**CITY PLANNING COMMISSION**  
 1231 "I" STREET, SUITE 200, SACRAMENTO, CA. 95814

B. Special Permit to develop a 178 unit apartment complex on 8.85± vacant acres in the Multi-Family Planned Unit Development (R-2B PUD) zone and within the Laguna Meadows PUD

**LOCATION:** Southwest corner, Jacinto Avenue and Bruceville Road

# HUNTERS POINTE

## SITE STUDY

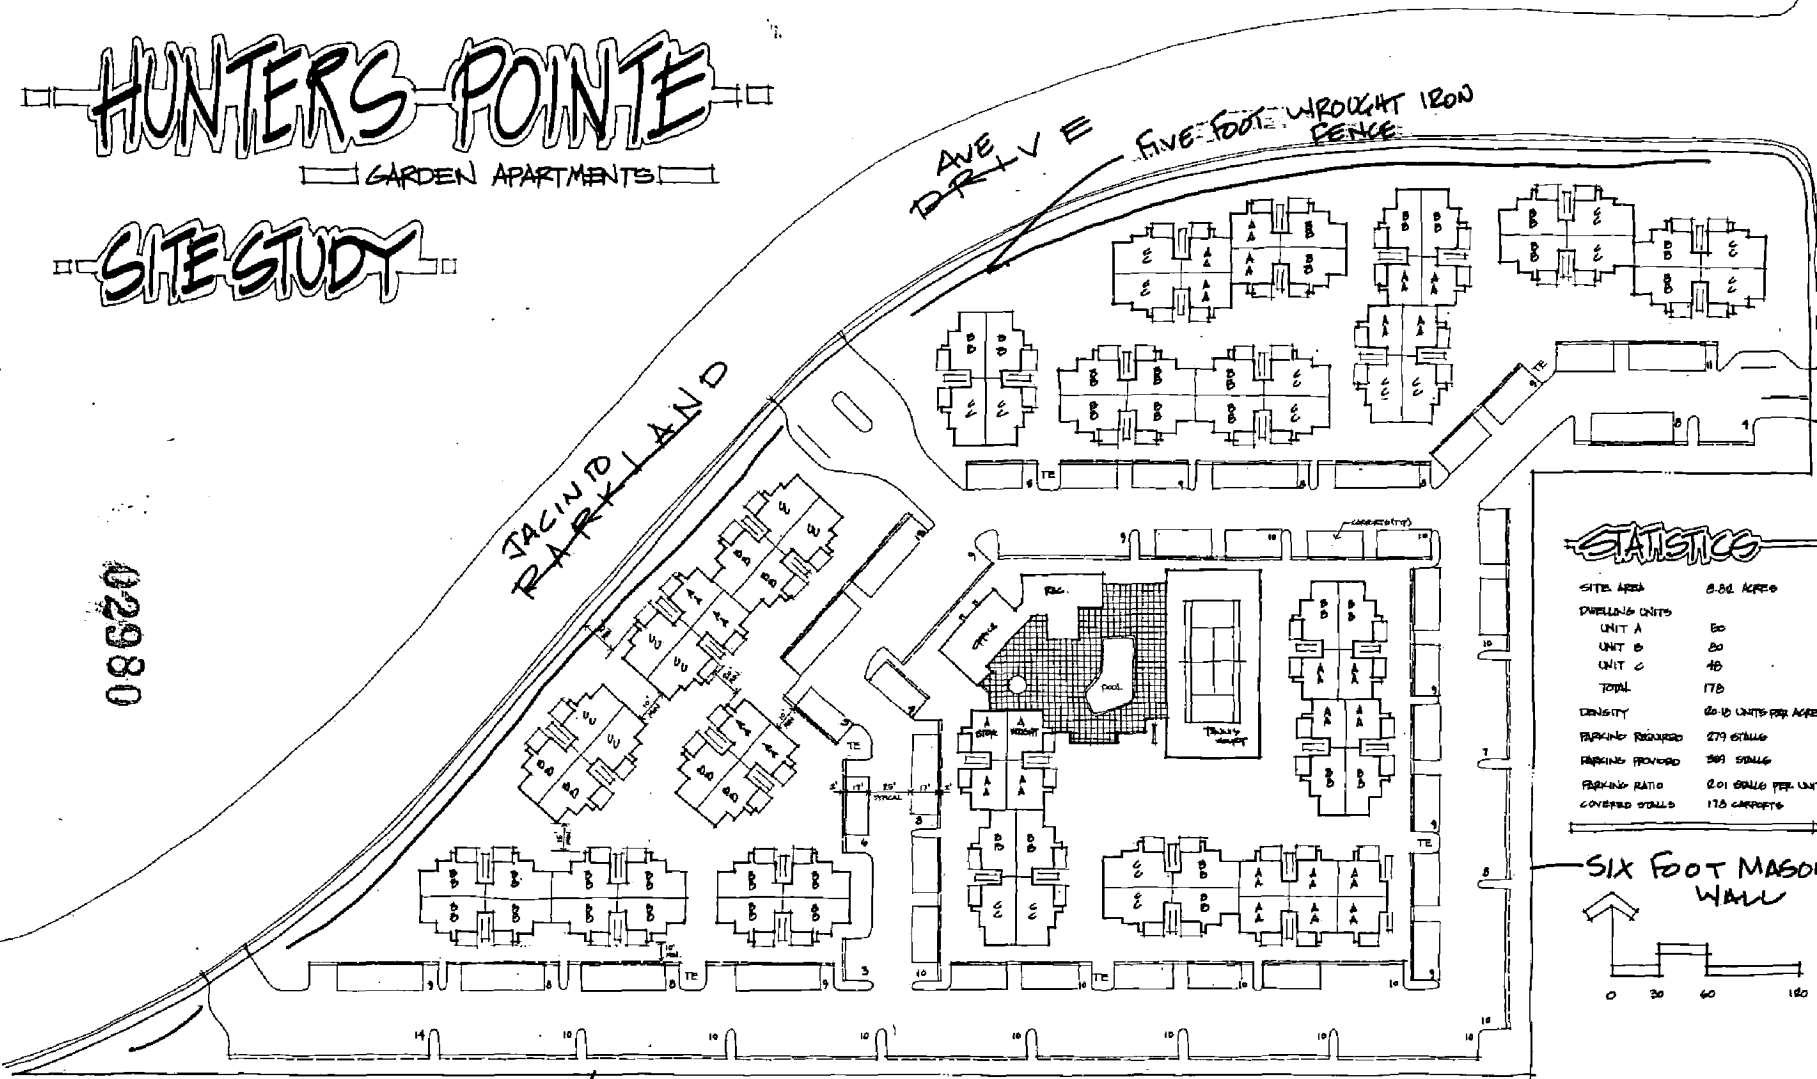
The submitted site plan indicates thirteen building clusters consisting of three unit types. Proposed unit breakdown is as follows:

Buildings are two-story consisting of eight or sixteen units per building. Proposal includes pool, recreation center, tennis courts and tot lot.

Access into the project is from both Jacinto Avenue and Bruceville Road. Based on the PUD parking standards, 279 parking stalls are required. The applicant has provided 359 stalls, of which 178 are to be covered in carports. The PUD and zoning ordinance requires a six foot decorative masonry wall on interior property lines between parking lot areas and existing or proposed residential development.

1. Maximum Driveway width is 35 feet.
2. Medium Islands in driveway will be a minimum of 20 feet back of property line.
3. Access on Bruceville will be right in/right out only.
4. Remove turn-out at entrance of main driveway.

1. A master plan for construction of public improvements of all parcels within the Laguna Meadows PUD is required prior to approval.
2. Comply with PUD Guidelines.
3. Align main entrance with street in Laguna Verde Subdivision (P88-220).

1. The applicant shall submit a revised site plan to planning staff for review and approval prior to issuance of building permits.
2. The applicant shall construct a six (6) foot decorative masonry wall along the south and east property lines adjacent to proposed and existing single family development. The design of the wall shall be reviewed and approved by staff prior to issuance of building permits.

3. The applicant shall construct a five (5) foot decorative wrought iron fence along the entire Jacinto Avenue frontage.
4. Trash enclosures and bicycle storage facilities shall conform to the City's Zoning Ordinance.

9. Access on Bruceville Road shall be right in/right out only.
10. Applicant shall align main entrance with street in Laguna Verde Subdivision.
11. Building plans shall be to the satisfaction of the City Fire Division.

## PRELIMINARY LANDSCAPE PLAN

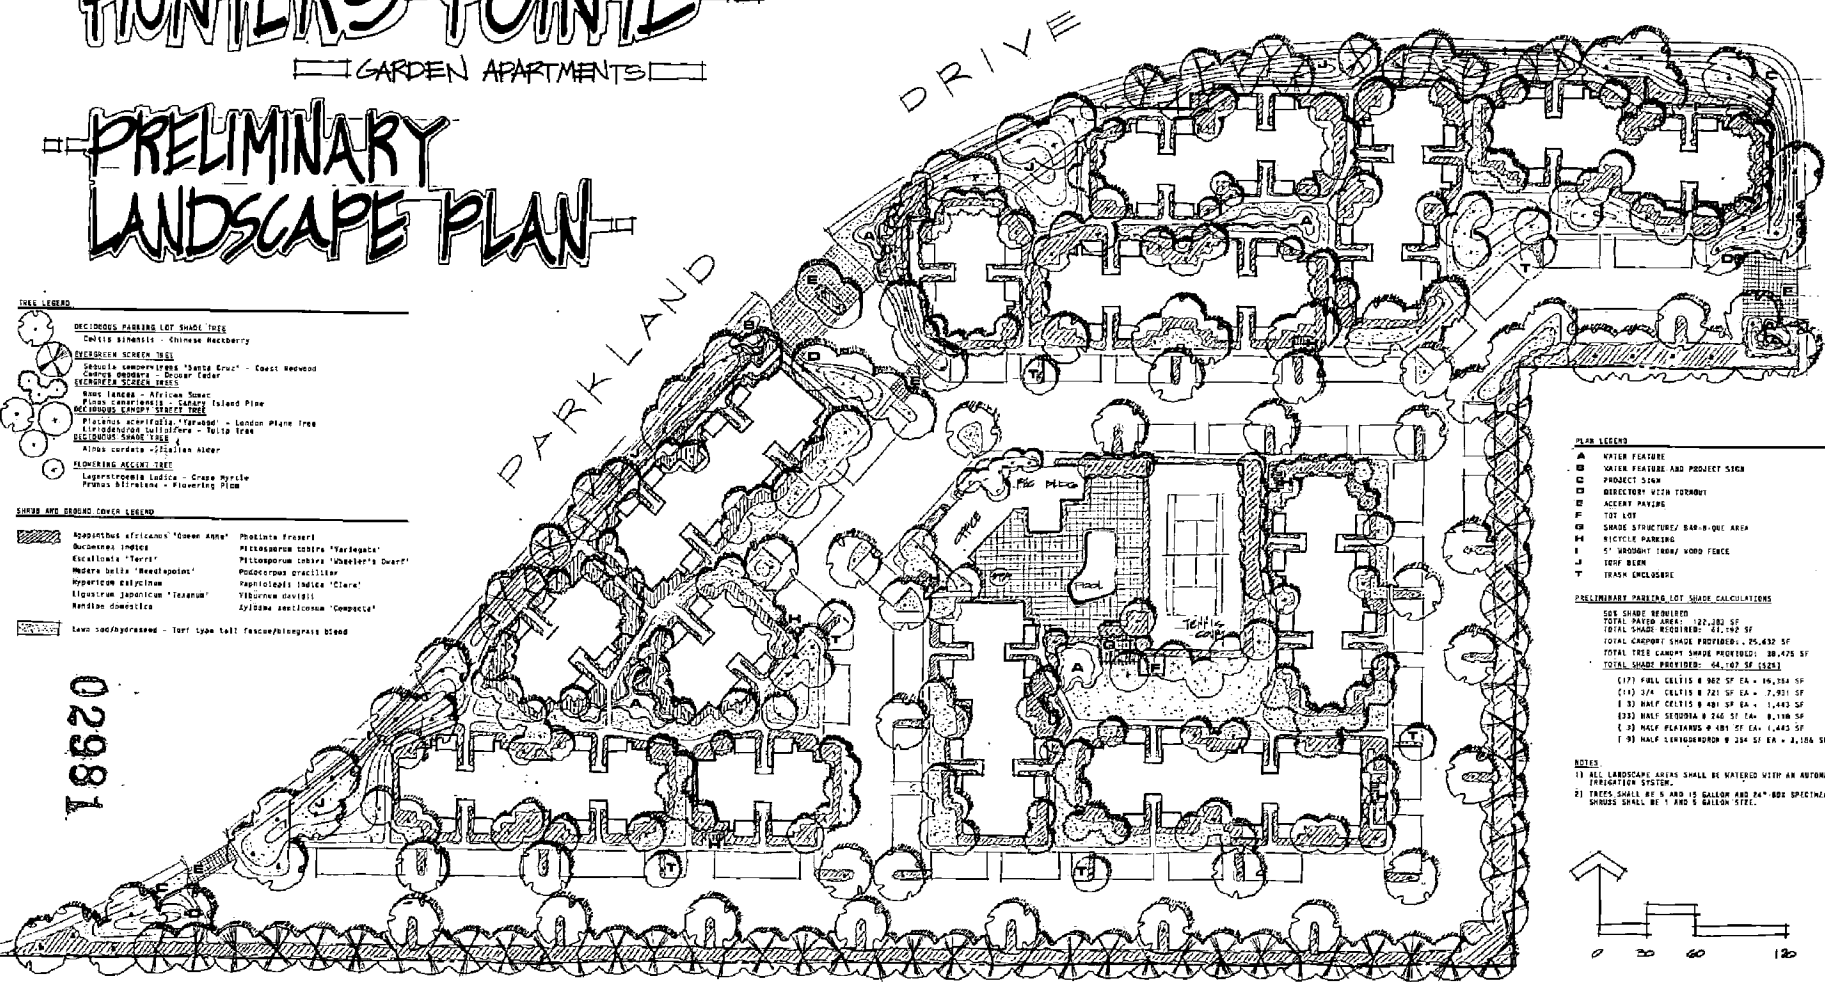
Planning staff also suggests locating a 5 foot high decorative wrought iron fence along the entire length of the Jacinto Avenue frontage. The use of the wrought iron fence will discourage on-street parking by project residents. The submitted landscape plan illustrates this wrought iron fence. The landscape plan indicates the use of contrasting paving materials at the entrances. Staff wants to note that this paving must meet Zoning Ordinance requirements. Staff suggests the use of stamped concrete or boumanite in these areas. The submitted preliminary landscape looks acceptable. However, staff needs to review and approve the final landscape plan prior to issuance of building permits.

5. A final landscape plan shall be submitted for review and approval by Planning staff prior to issuance of building permit.
6. The building elevations shall consist of cement plaster, individual 4 inch wood siding with concrete tile roofing material or equivalent to be approved by staff. Revised elevations shall be submitted for staff review and approval prior to issuance of building permits.

EXTERIOR ELEVATION  
SCALE: 1/8" = 1'-0"

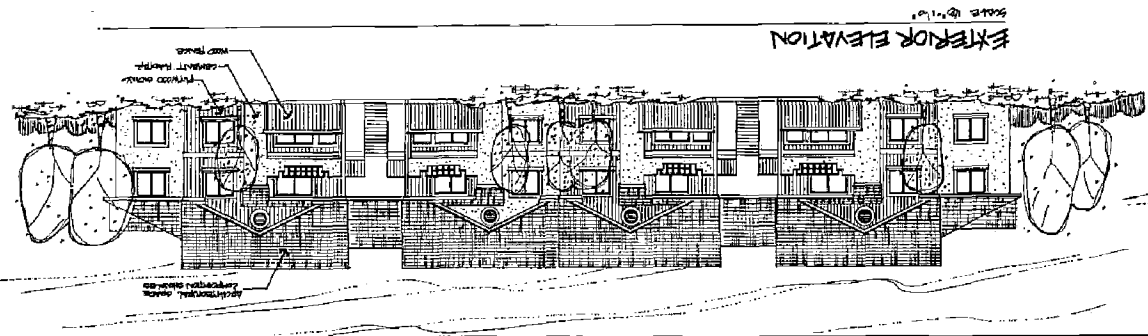
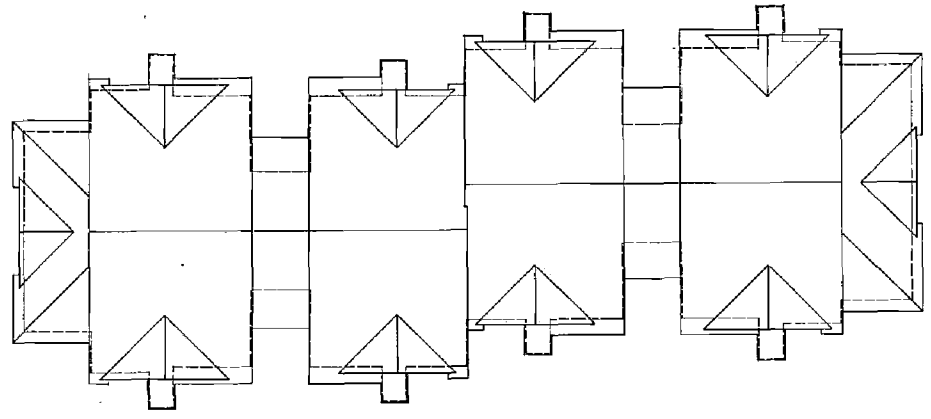
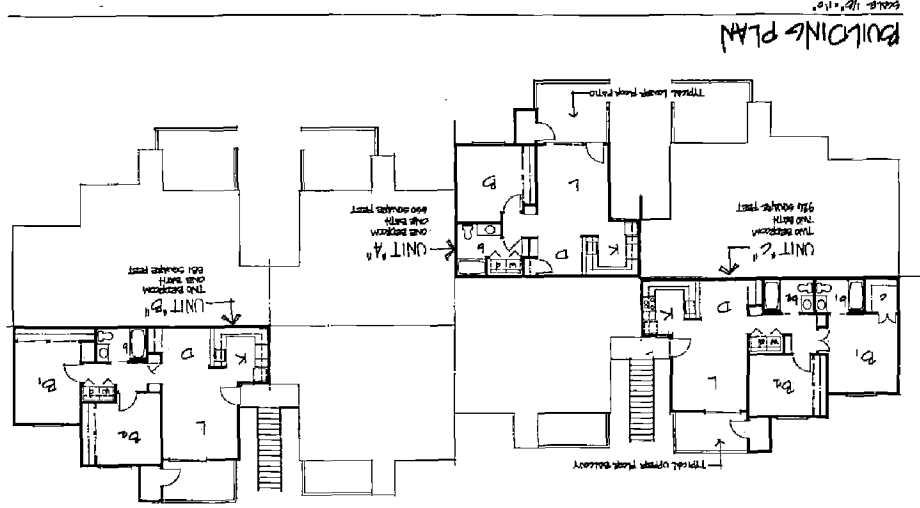
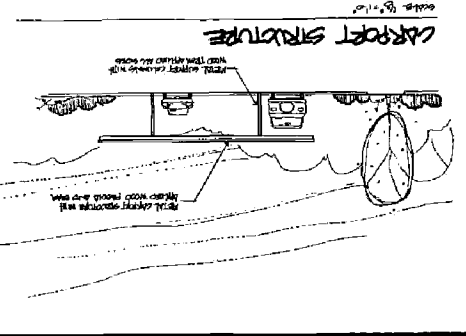
The applicant proposes building exteriors consisting of cement plaster and plywood siding with composition shingle roofs. Staff has some concerns with the quality of the exterior materials. Staff had stated these concerns in the preliminary review prepared for this project. Staff recommends the following revisions to the elevations:

- \* 4 inch horizontal wood siding should be utilized instead of the proposed plywood siding.
- \* Patio fencing should be compatible with the horizontal wood siding on the main structures.
- \* Roofing material should be concrete tile or equivalent approved by staff prior to issuance of building permits.
- \* Carports should be compatible in design with main buildings. Flat roofs are discouraged in the PUD Guidelines. Staff suggests pitched roof or other roof variation.

The applicant should submit revised building elevations for review and approval by Planning staff prior to issuance of building permits.
